Addendum No. 02

Issued: 9/13/2024

Project Name: Jordan Learning Center
Project No.: 2024528.00
Bid Package: 1

SHEET NUMBER:
SF504

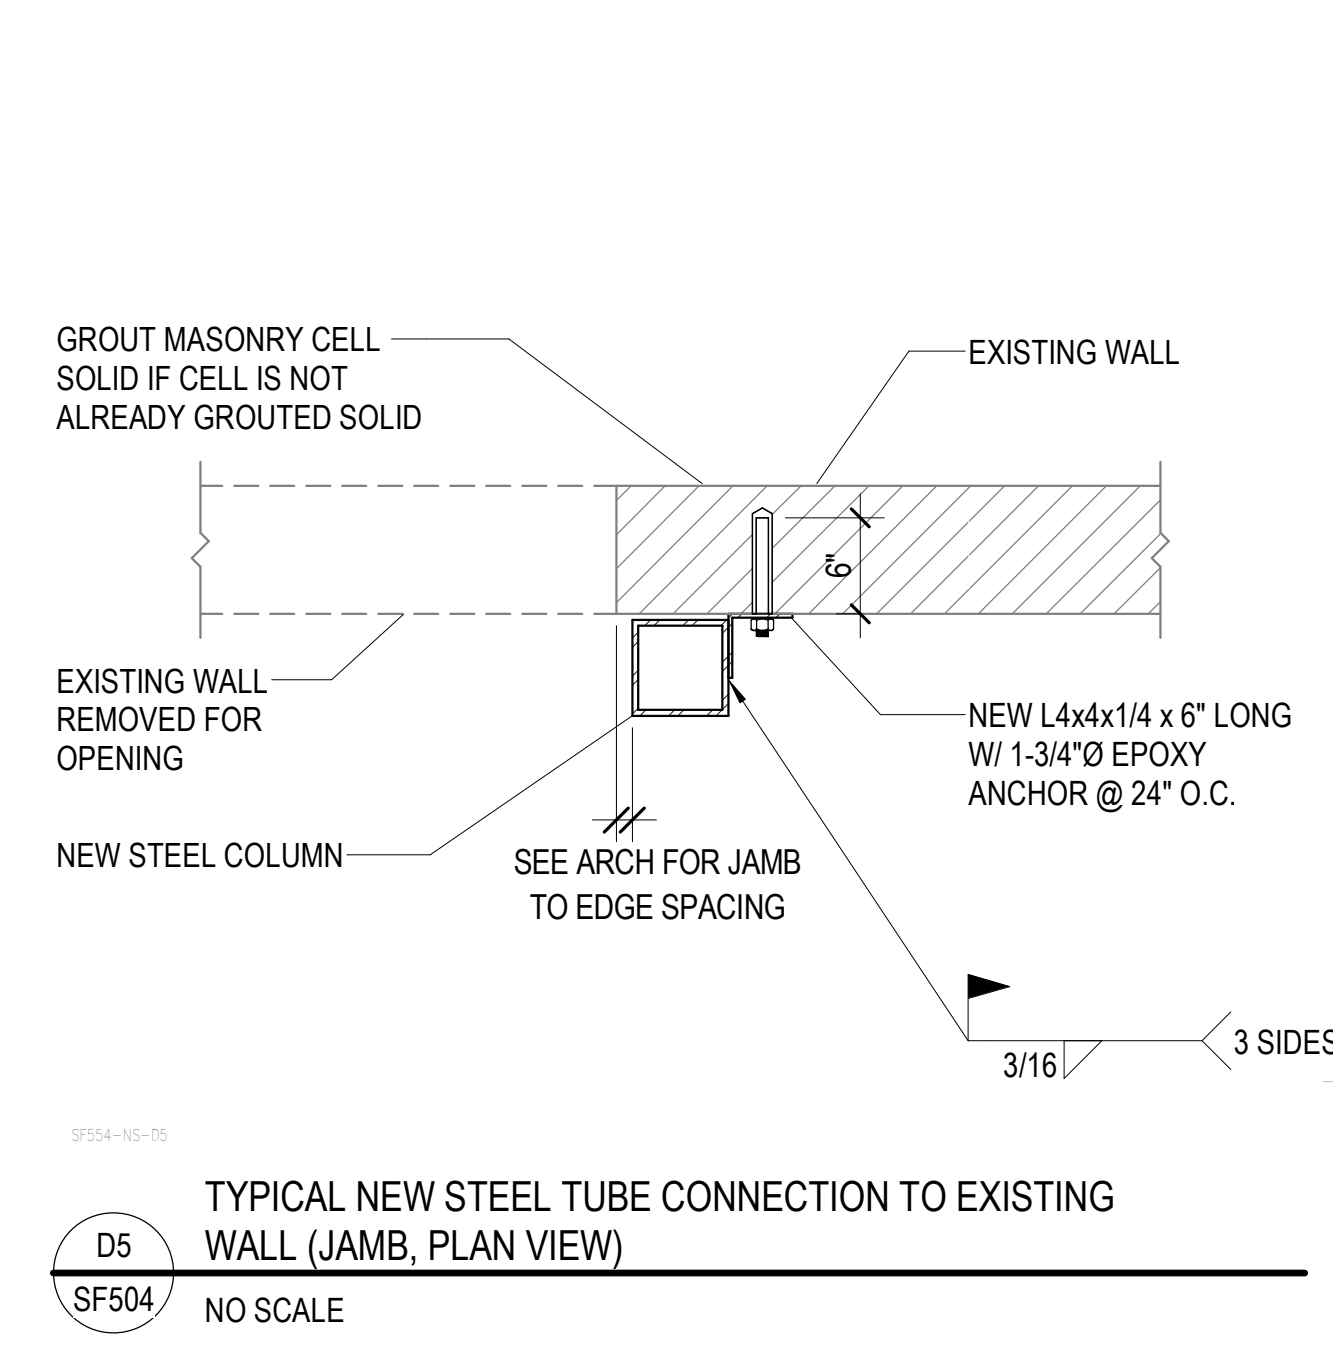
- Updated detail C3 to include HSS lateral support end connections.
- Revised references on details D1 and D2.

SHEET NUMBER
A101A

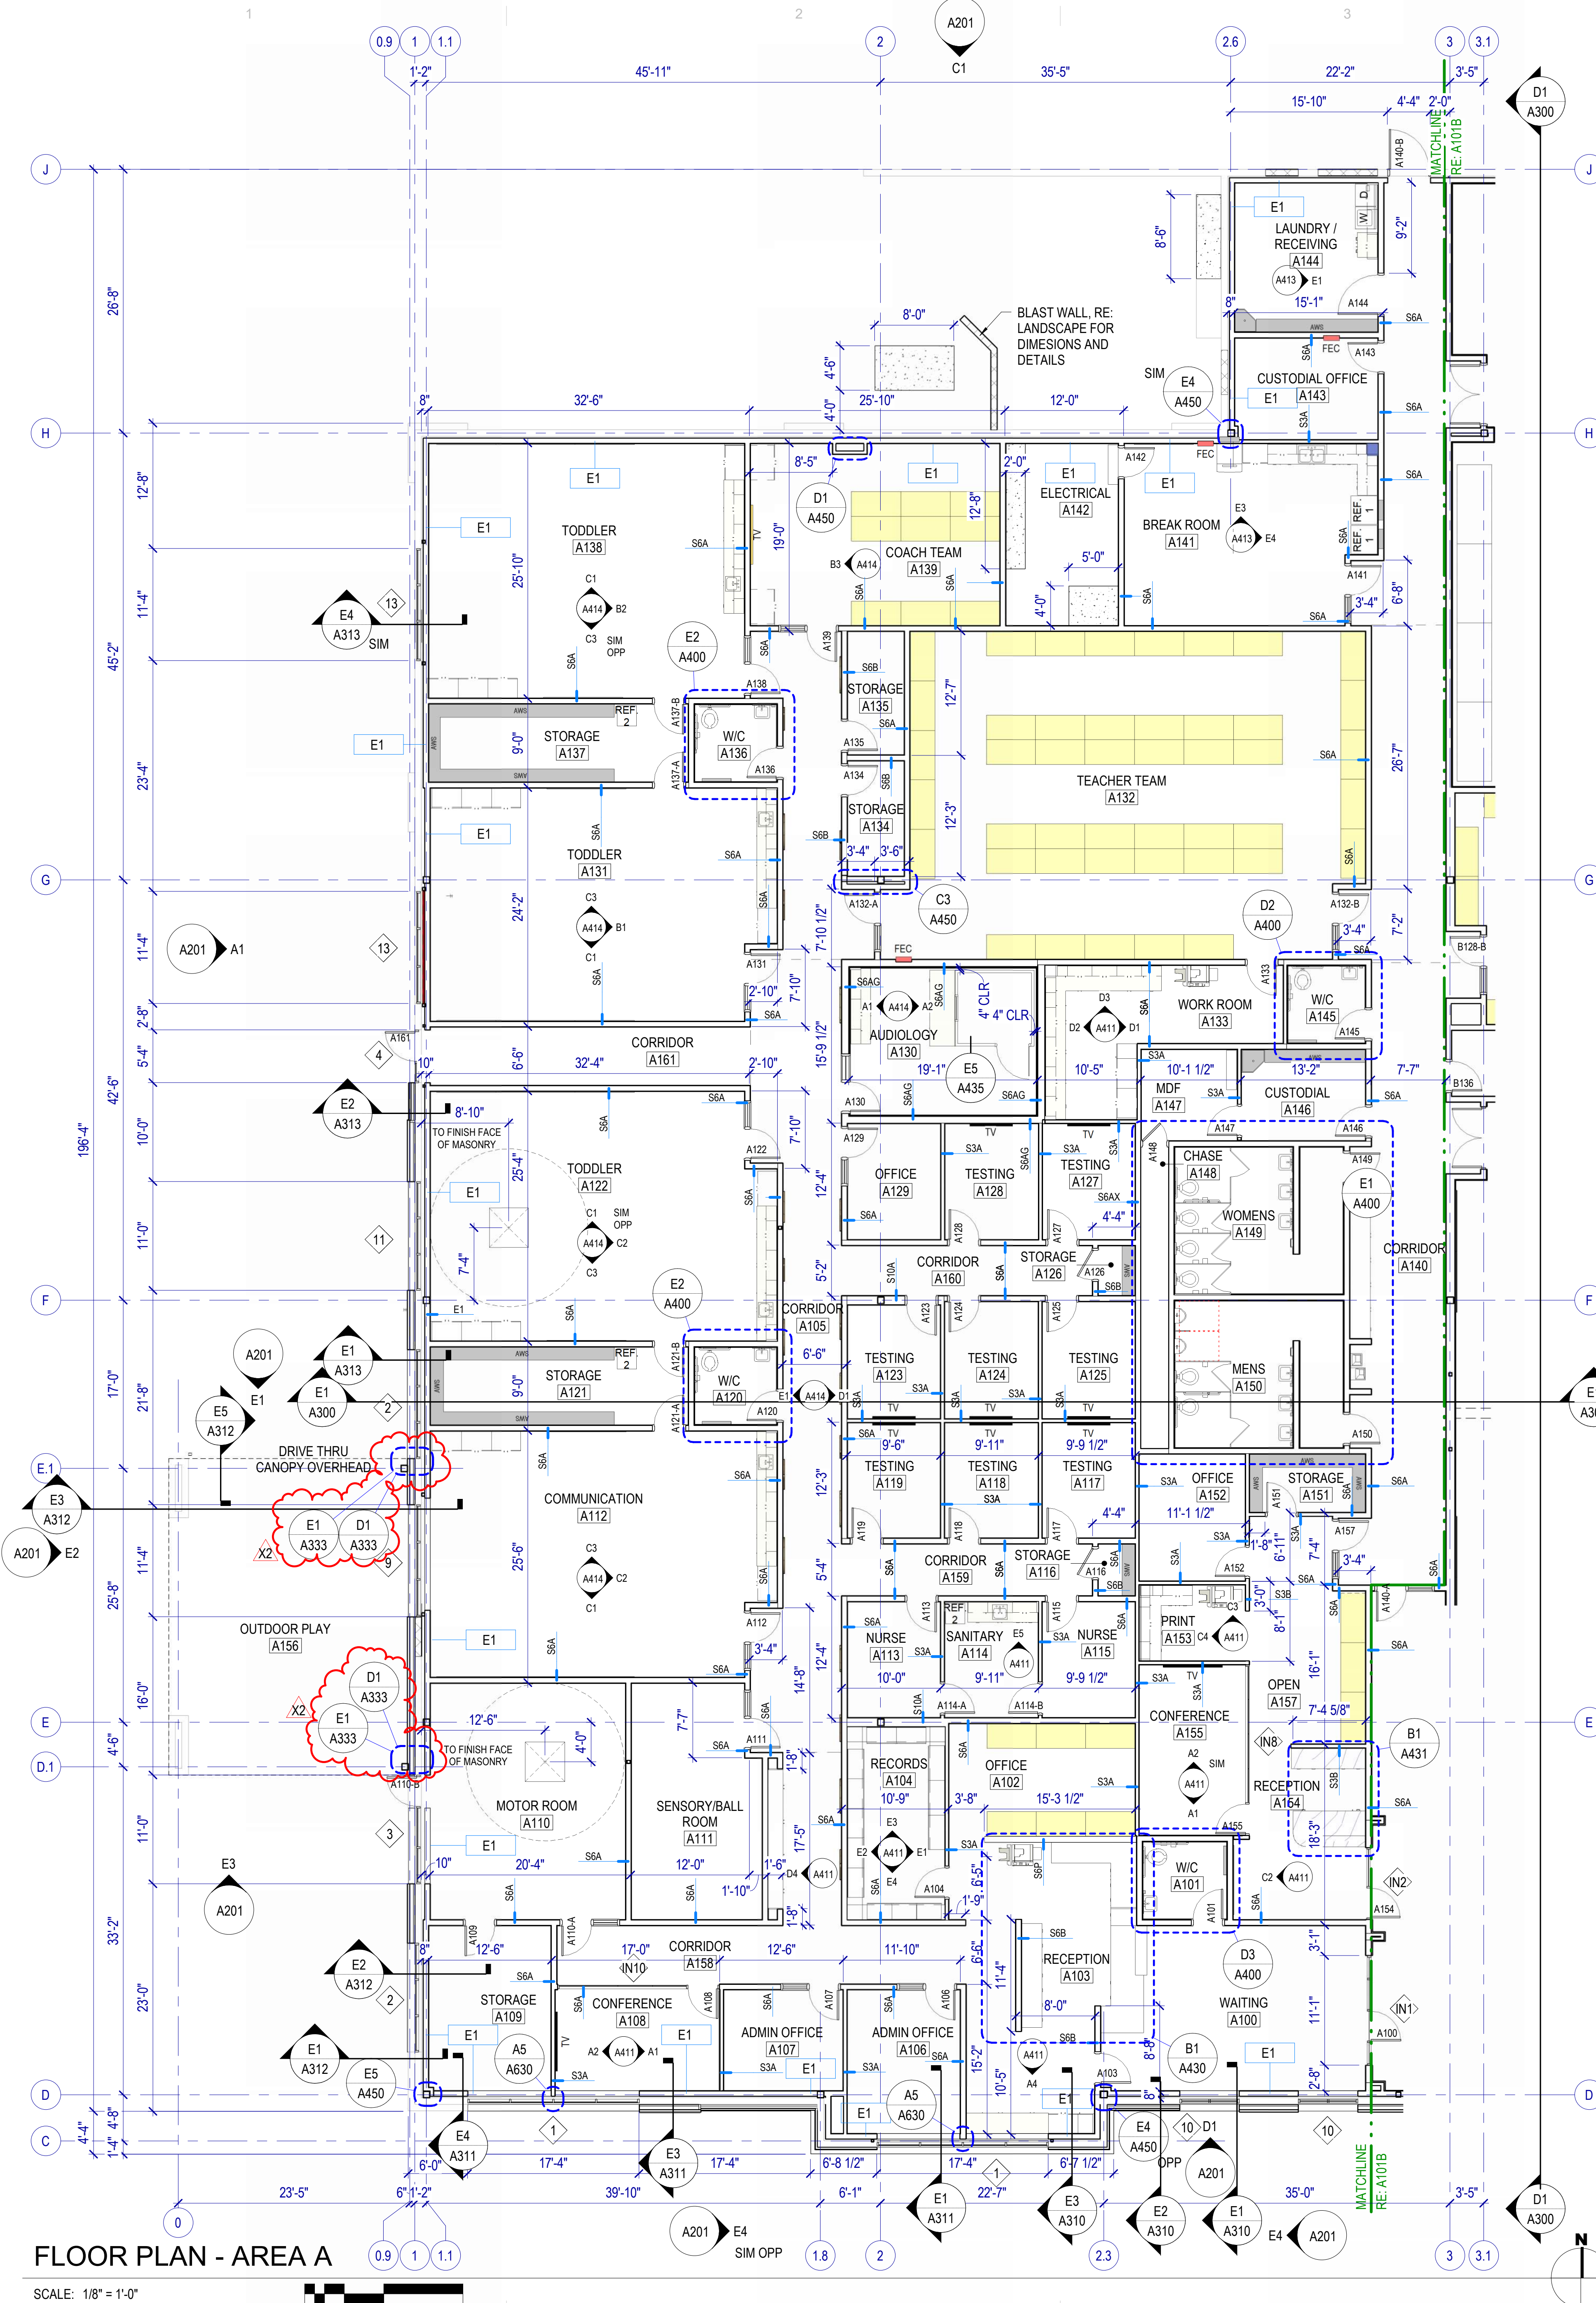
- Revised Drawing to show Callouts to added Details D1/A333 & E1/A333

SHEET NUMBER
E311A

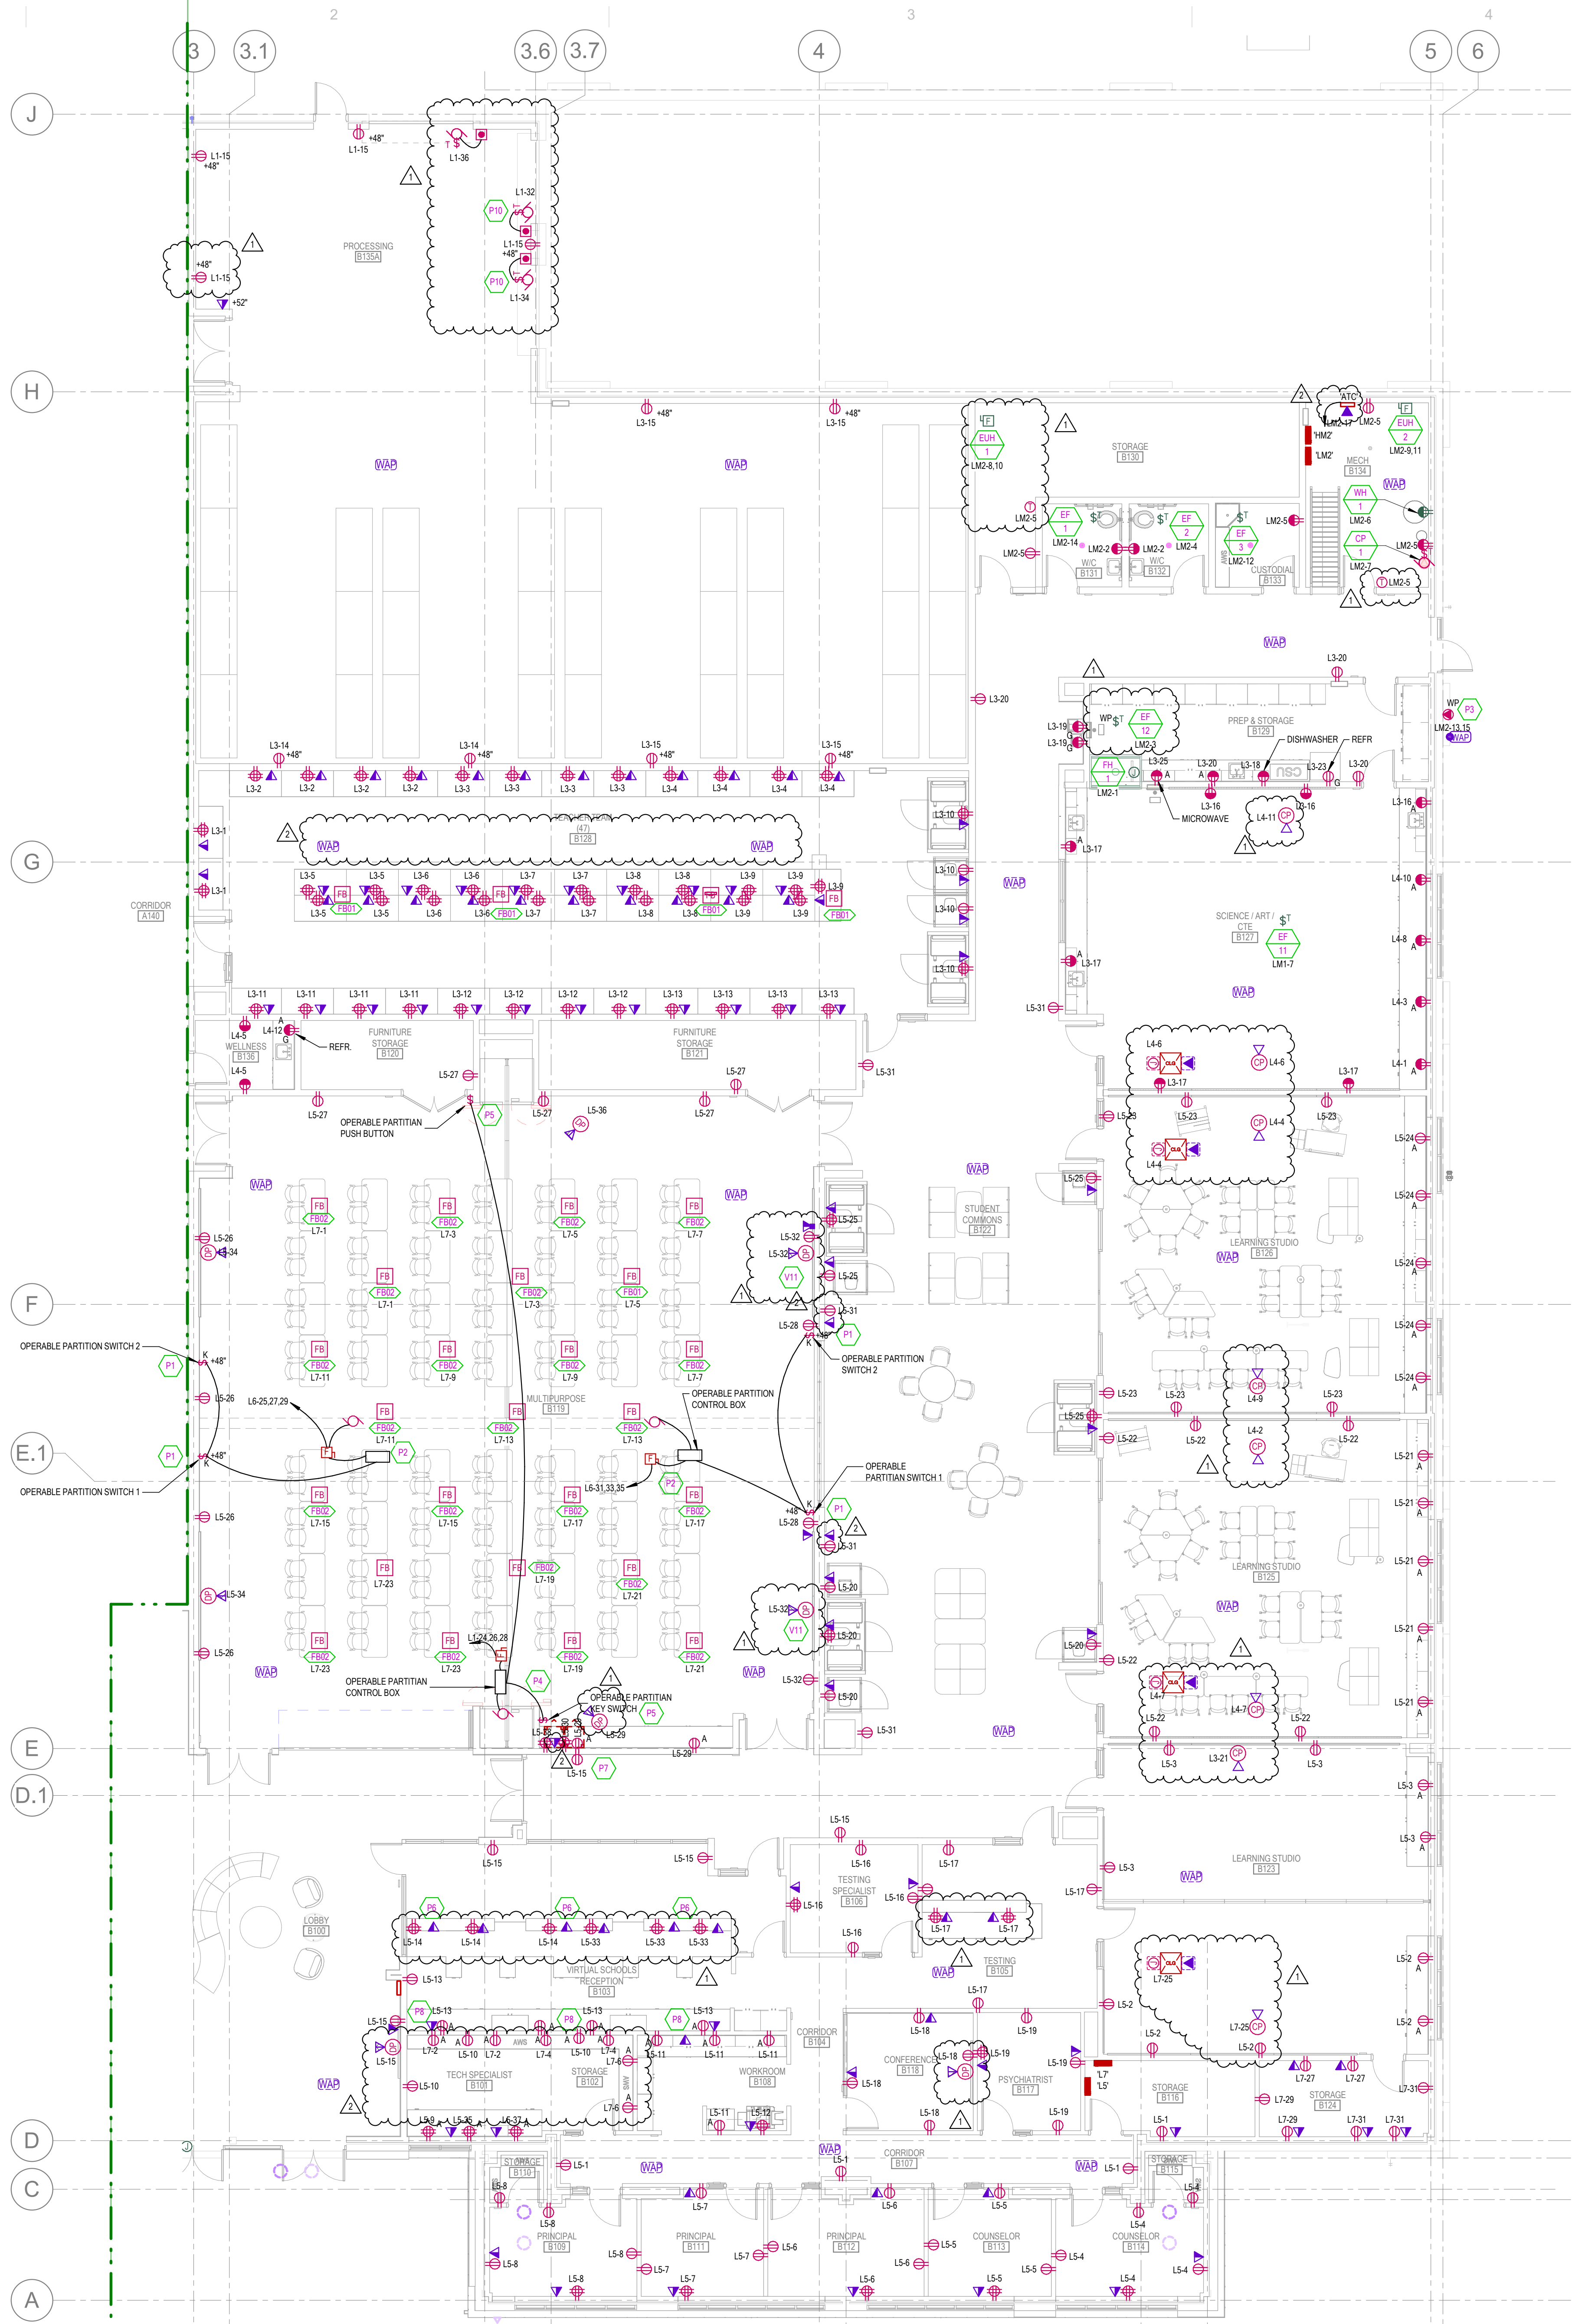
- Teacher Team A122. Change the circuit numbers on the four-plex receptacles along the west wall to L3-22 and 24, evenly distributed. Change the circuit numbers on the four-plex receptacles along the east wall to L3-28 and 30, evenly distributed. Change the circuit numbers on two of the four-plex receptacles along the south wall to L3-26.
- Coach Team A139. Provide a 2 drop data outlet at the DP. Connect the DP to circuit L1-3.
- Custodial A143. Provide a wireless access point.
- Sensory A111. Provide a 2 drop data outlet adjacent to the duplex receptacle on the east wall.
